Subject: Modified Tunnel Option for Downtown San Jose

Responses to City of San Jose's Proposal for Modified Tunnel Option for HST Design in Downtown San Jose Area

Re: Technical Study Report for Modified Tunnel Option in City of San Jose

Figure 1 – Interpretative Geologic Profile – Summary Sheet

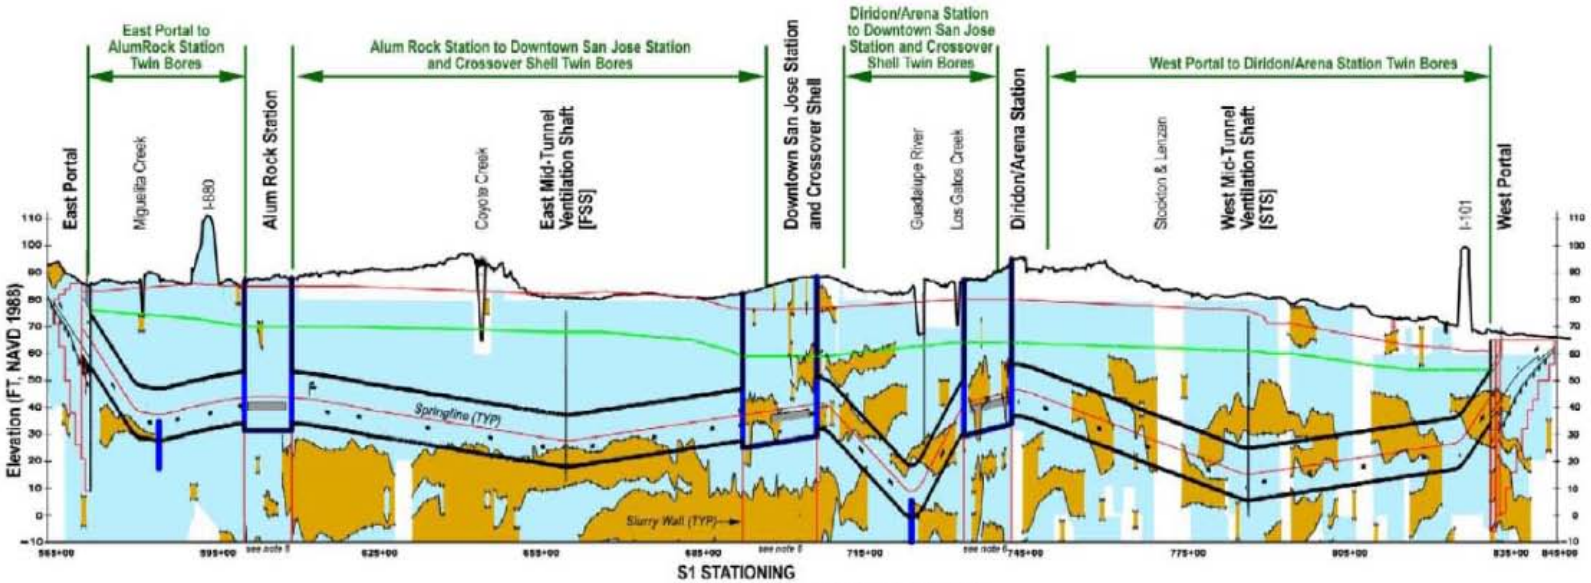
In the vicinity of Guadalupe River and Los Gatos Creek, particularly at their confluence close to the Diridon Station, much variability in the ground conditions has been found and this can be seen in the long sections in Figure 1 and Exhibit 1. This is normal in the vicinity of rivers as they are high energy environments with erosion and deposition occurring simultaneously.

At Diridon Station, sand and gravel lenses and layers have been identified in boreholes from depths of 30 feet to depths of 150 feet below ground level, extending over the full 800 feet length of the proposed BART Station. Ground conditions do not improve with a medium depth station located at 110 feet below ground level compared with a deep station at 140 feet depth, as sand and gravel lenses are still present although the water pressure is reduced.

Exhibit 1 – BART Diridon Station Ground Investigations

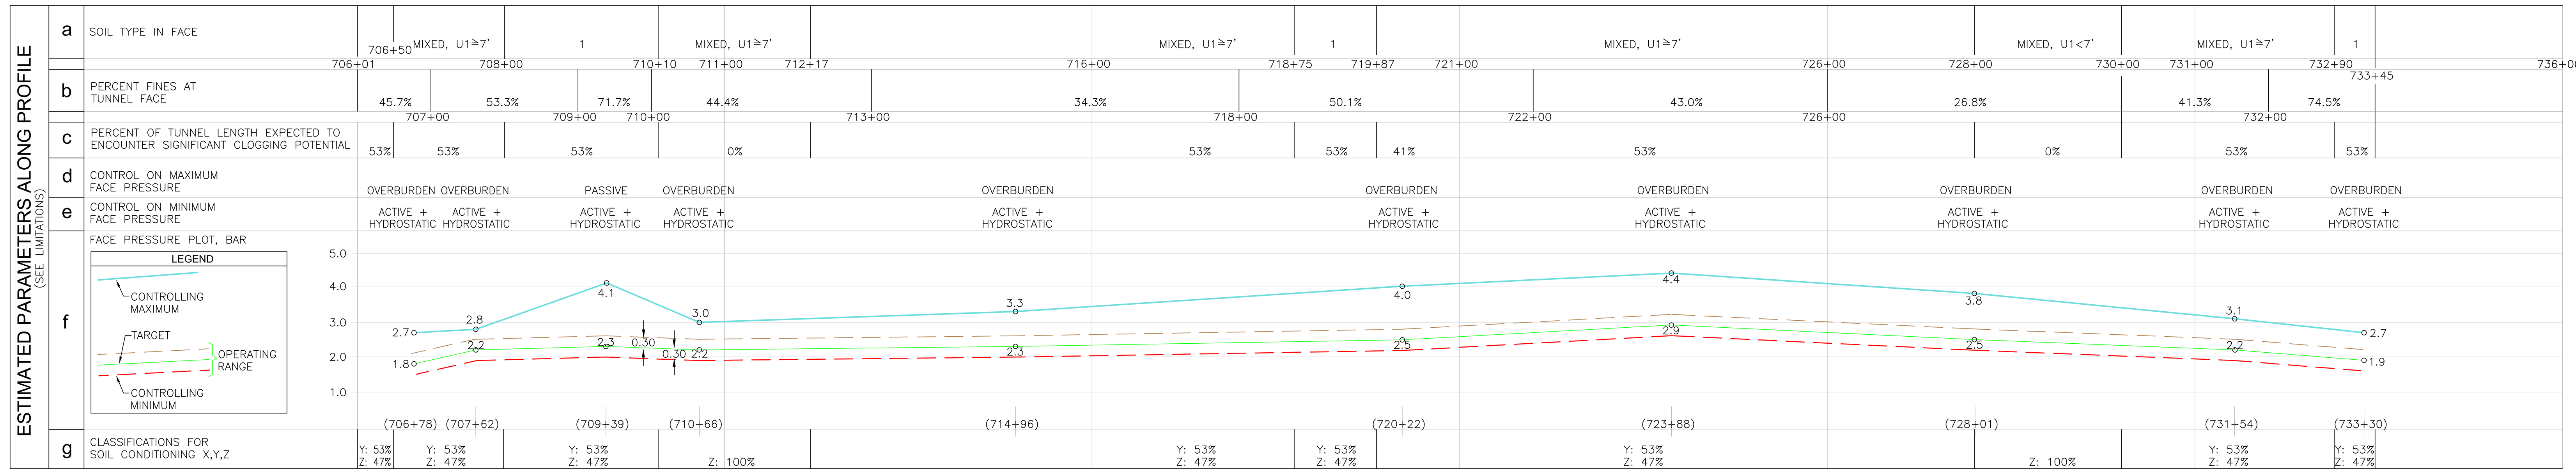
As shown in Exhibit 1 (BART Diridon Station Ground Investigations) these conditions are very different to those in San Jose, where we have an initial (shallow) layer of clay and then alternating layers of water-bearing gravels, sands, and silts at the deeper elevations. These conditions are far more challenging for mined underground construction.

These conditions are very different to those in San Jose, where we have an initial (shallow) layer of clay and then alternating layers of water-bearing gravels, sands, and silts at the deeper elevations. These conditions are far more challenging for mined underground construction and geology.

TYPICAL TRACK LAYOUT, INTERMEDIATE STATION WITH HIGH SPEED TURNOUTS

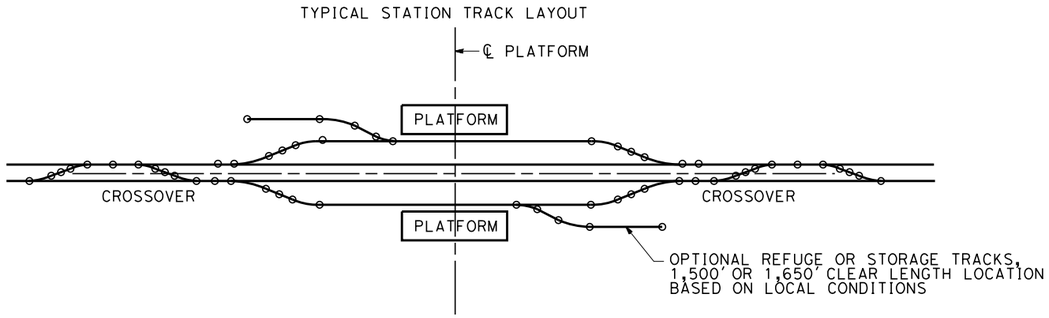
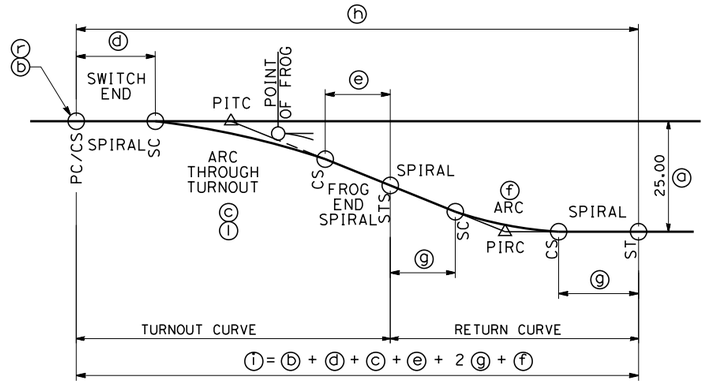
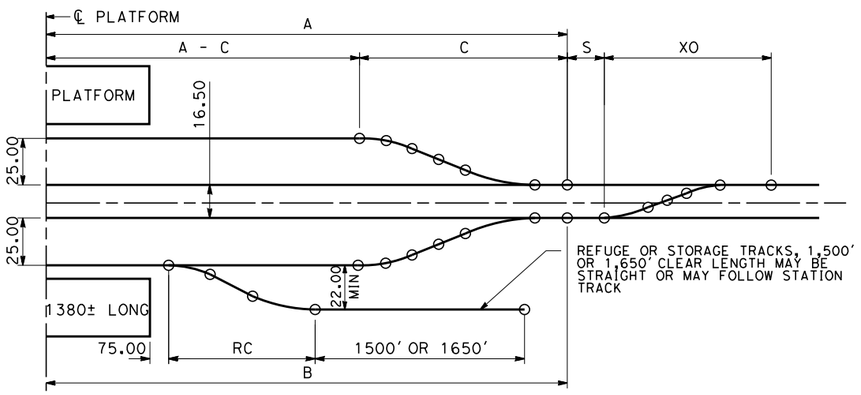
For preliminary design, CHSTP has prepared a directive drawing showing a typical surface intermediate station track arrangement (see Exhibit 2). Although this is for side platforms, with through center tracks, the following logic would also apply to the four train tunnel configuration:

- 110mph turnouts and through train speeds (same as previous deep tunnel option).

- 3000 feet minimum station approach track after turnouts to allow for deceleration of stopping trains.
- Symmetrical approaches to allow for changed direction of travel on any line.

With station track centers of 200 feet (compared with track spacing of 50 feet with previous cavern alternative) and the requirement for bypass tunnels outside station tunnels, turnouts have to be located at a much further distance from the station than with the previous deep tunnel cavern option (which had track centers of 50 feet). At the south end, turnouts would have to be located at the surface which requires the portal to be 200 feet wide to accommodate four separate tunnels. This would cause significant property take at this location. At the north end, underground turnout caverns would be required at an increased distance from the station, and this in turn increases the length of the bypass tunnels.

Exhibit 3 - Cross Section of Diridon Station Tunnel - Station 1

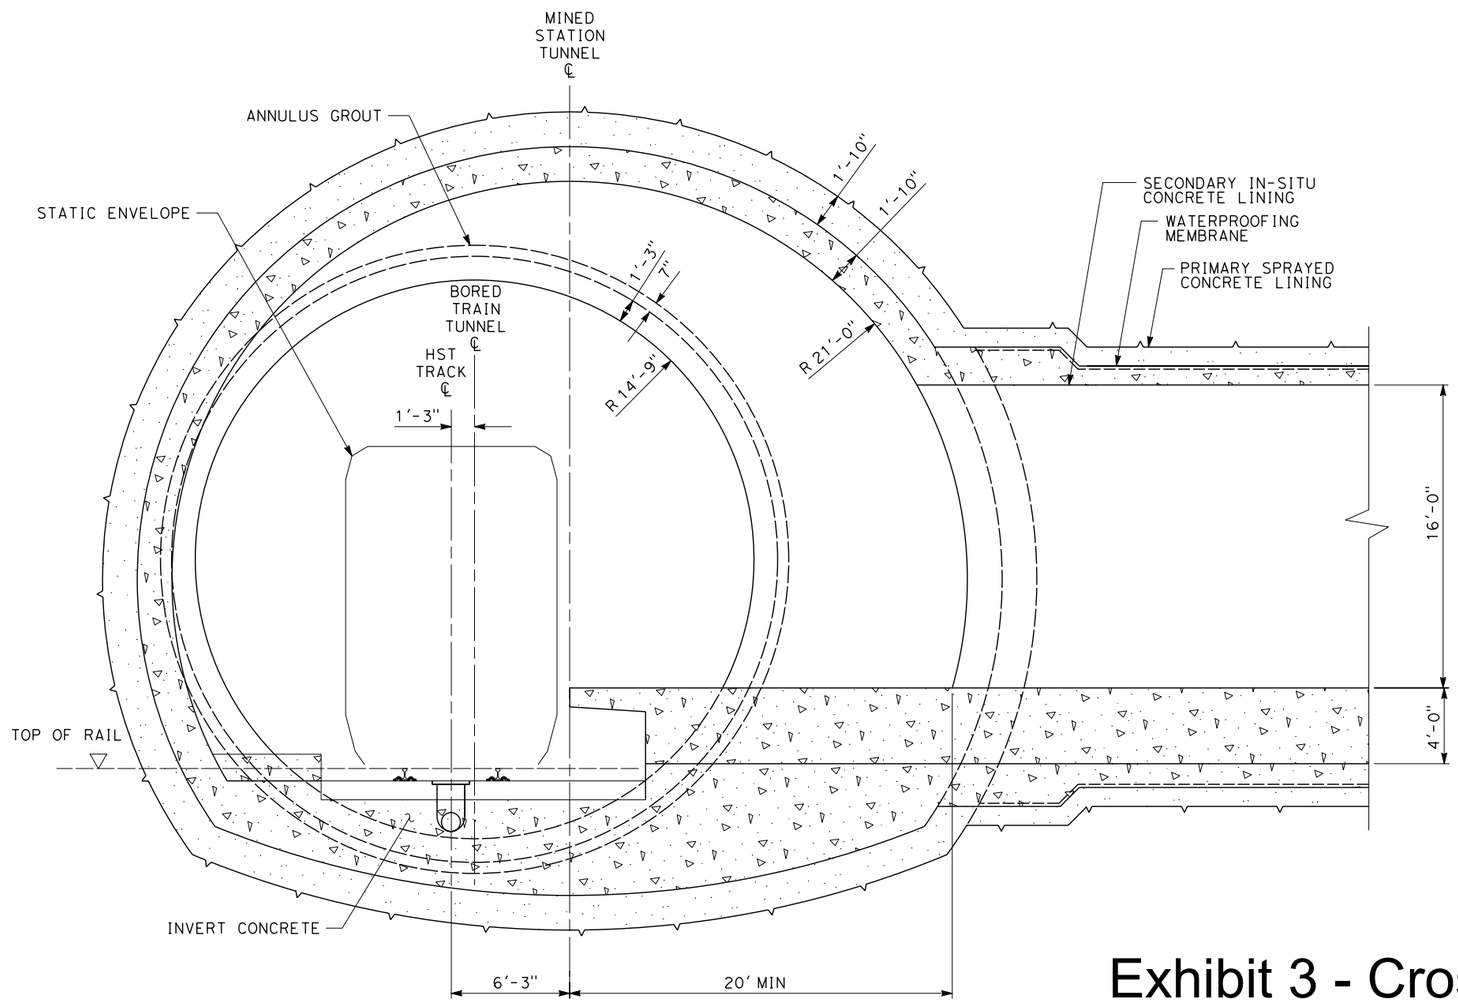
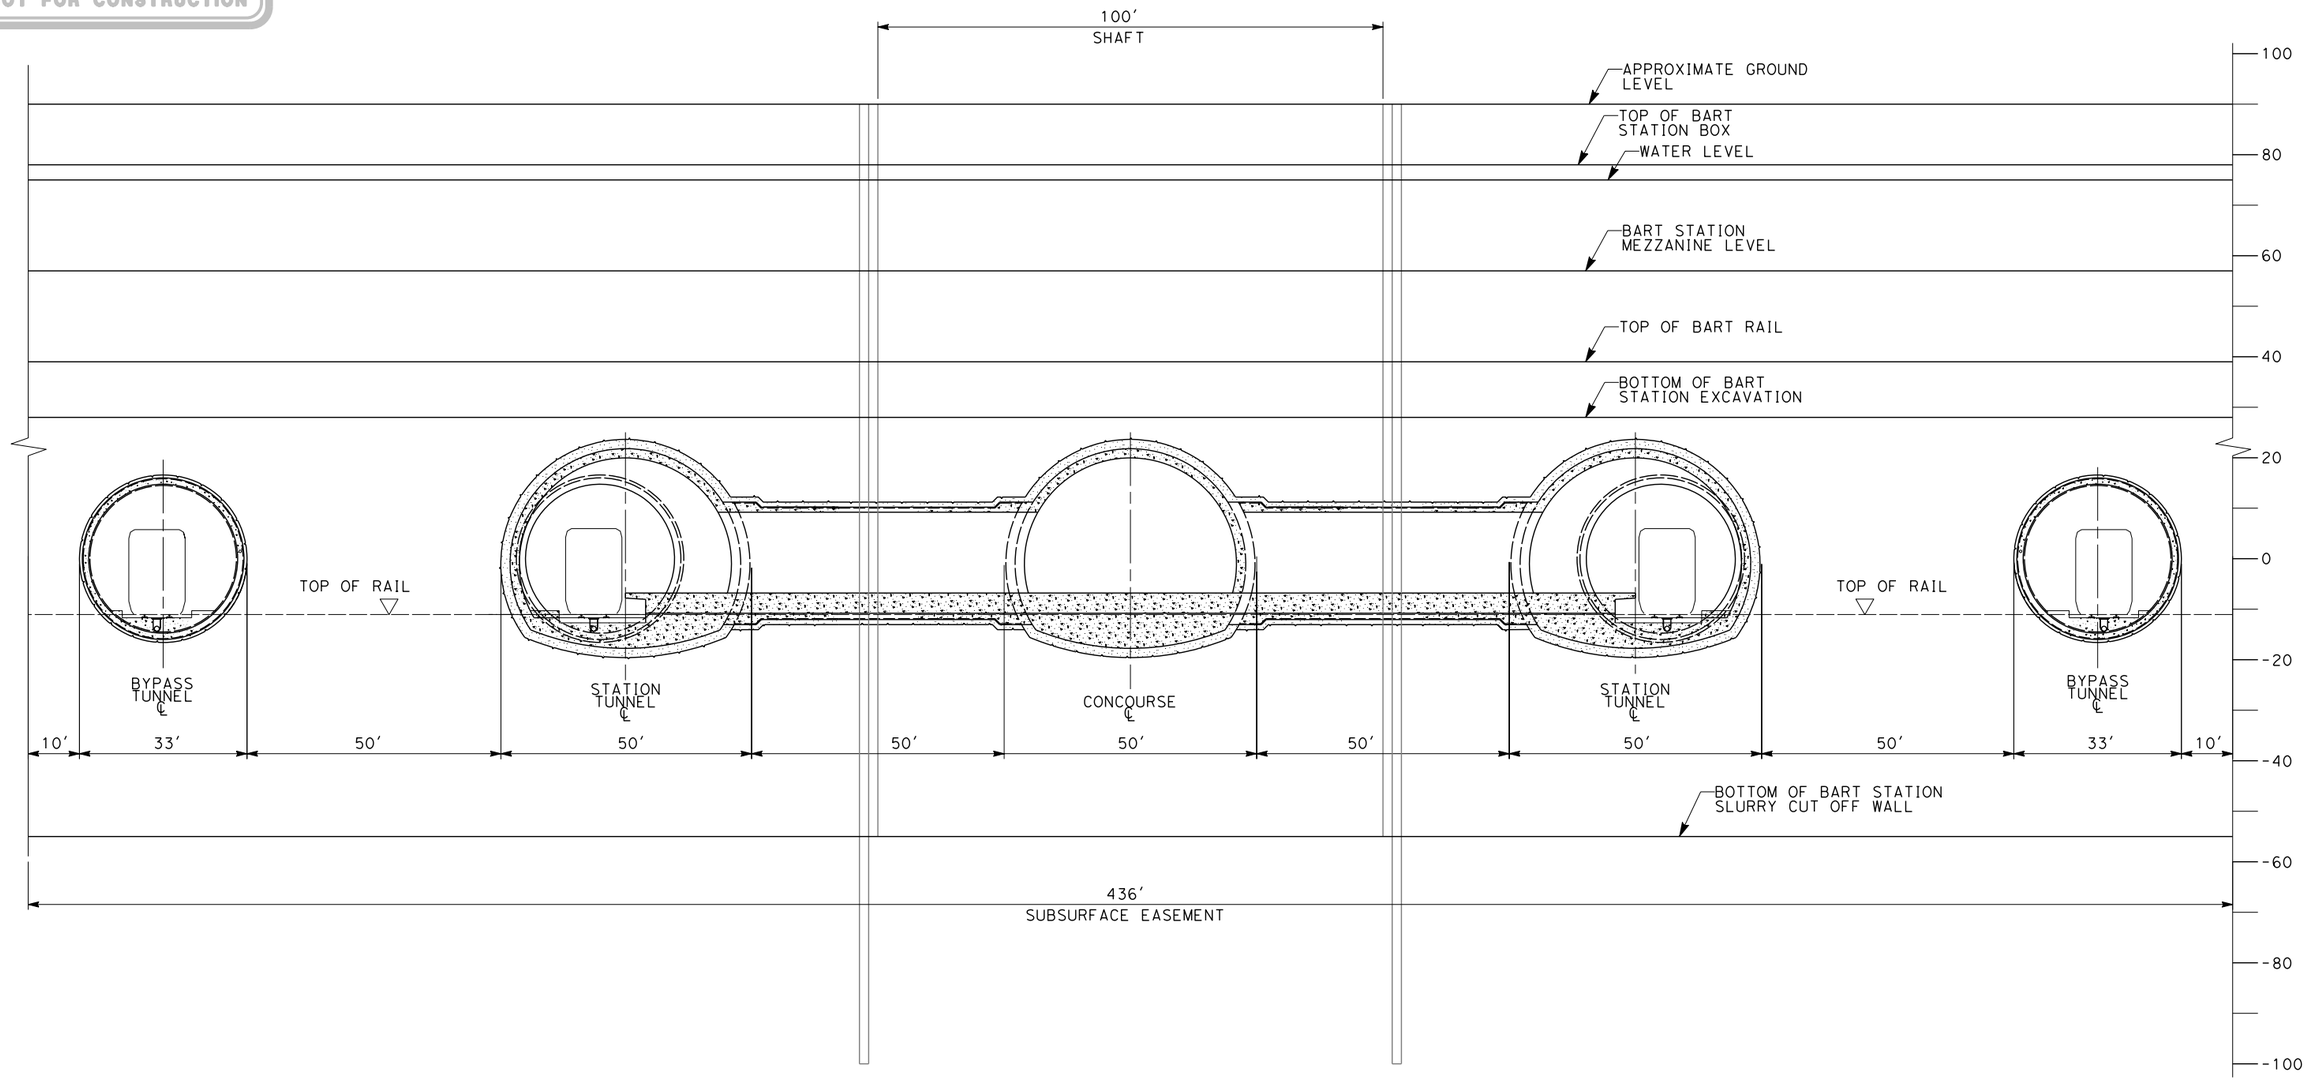
Please refer to Exhibit 3 (Diridon Station Exhibit 1 & 2). The preliminary internal tunnel diameter assumed on CHSTP is 29.5 feet (not 35 feet), which is an appropriate size considering that the trains have not yet been selected. As dictated by CAHSR project criteria, trains will be wide bodied trains commonly used in Asia and new high speed rail lines in Europe, rather than the narrow European trains that have to fit into existing infrastructure.

Please refer to Exhibit 3 (Diridon Station Exhibit 1 & 2). The preliminary internal tunnel diameter assumed on CHSTP is 29.5 feet (not 35 feet), which is an appropriate size considering that the trains

Each station platform requires a width of 20 feet exclusive of vertical circulation (elevators, escalators, stairways). Mined tunnels to accommodate station platform would therefore be 40 to 45 feet internal diameter. Allowing 24 inches for final lining and the same for primary lining gives 8 feet of liner so the excavated diameter would be about 48 to 53 feet. The central concourse tunnel would have a similar diameter.

A pillar of ground equal to one tunnel diameter in width is required between each tunnel for structural support so total width for the two station platform tunnels and the central concourse tunnel would be 250 feet. Track centers would be about 200 feet.

Each bypass train tunnel having an excavated diameter of 33 feet would require a ground pillar of 50 feet (equivalent to the tunnel diameter of the adjacent station tunnel) which would add 166 feet to give a total width of 416 feet approximately.

Exhibit 4 – Crossrail Exhibit of Tottenham Court Road Station

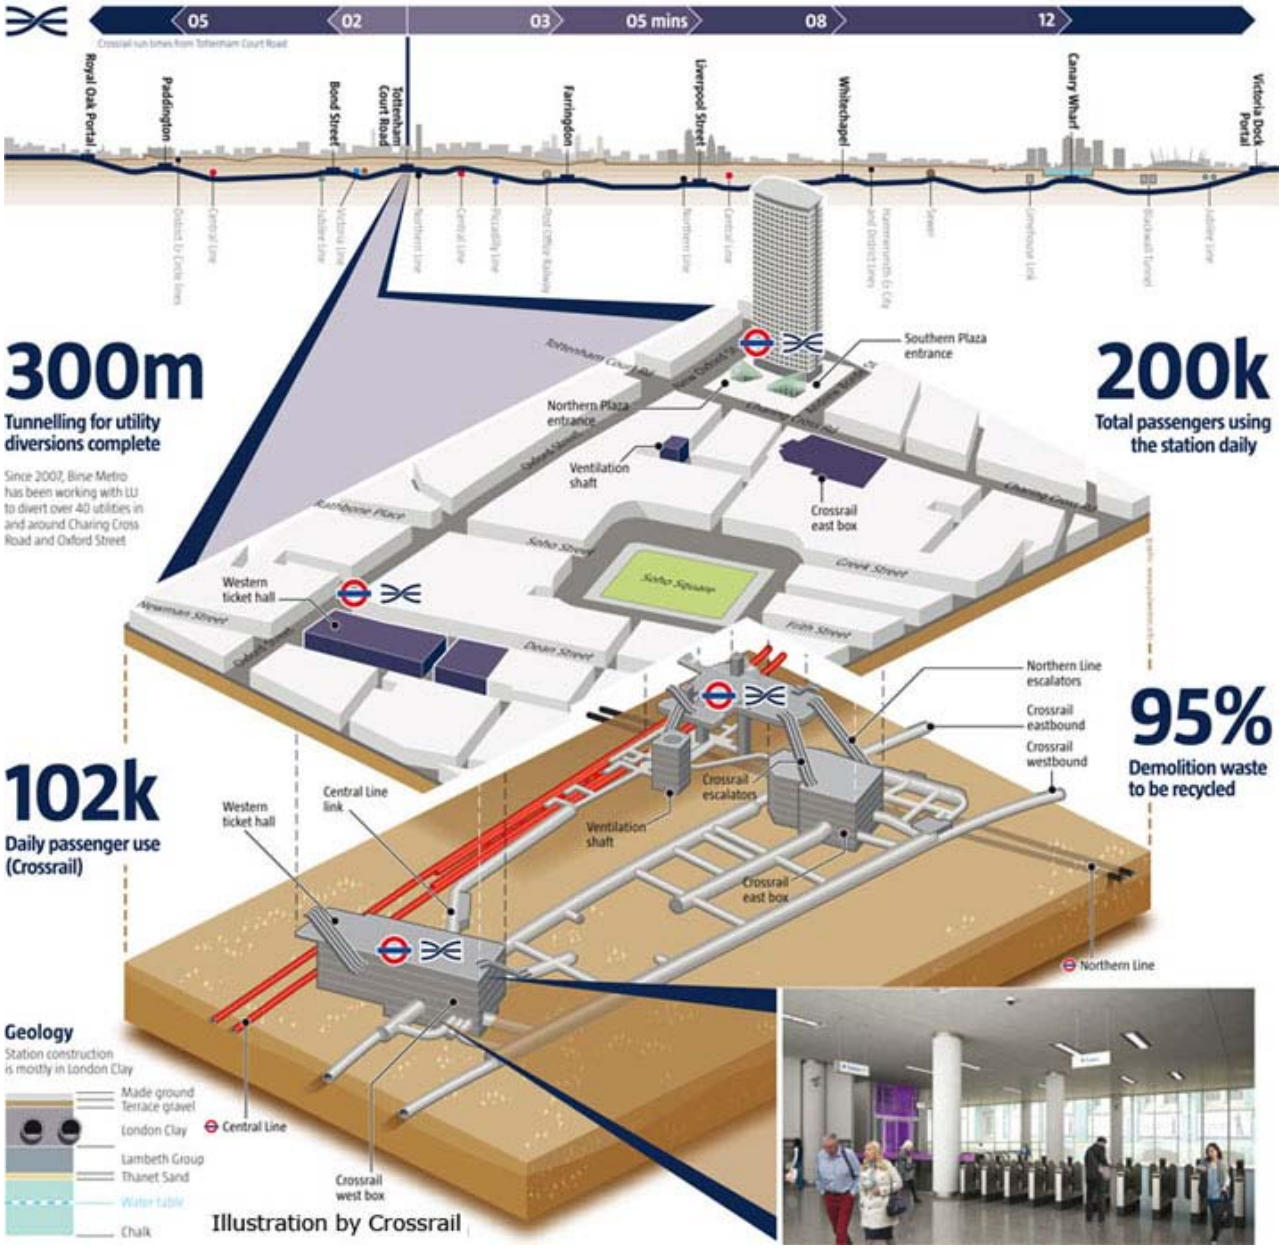
Similar to the Tottenham Court Road Station in London (see Exhibit 4), the proposed station configuration is comprised of three tunnels (two station platform tunnels and a center concourse tunnel.) This is a typical station configuration for transit systems around the world, and indicative, scaled drawings have been prepared showing a dimensioned plan for this configuration (see Exhibit 5). This is a much wider and longer station than the previous deep and shallow options due to the need to provide a center concourse tunnel. As a result, the underground construction would unfortunately impose severe limitations on locations of foundations for future developments. These foundations would need to be located between tunnels and extend below the tunnels so as not to impose loads on the subsurface facilities.

To elaborate, according to the graphic at the link below (and Exhibit 4), the geology is London Clay at the level of the station tunnels for the proposed Tottenham Court Road Crossrail Station in London. London Clay is the ideal tunneling medium, as it is soft, impermeable, and self-supporting for extended periods of time. In addition, the water table is below the tunnels.

According to the graphic at the link below (and Exhibit 4), the geology is London Clay at the level of the station tunnels for the proposed Tottenham Court Road Crossrail Station in London. London Clay is the ideal tunneling medium, as it is soft, impermeable, and self-supporting for extended periods of time. In addition, the water table is below the tunnels.
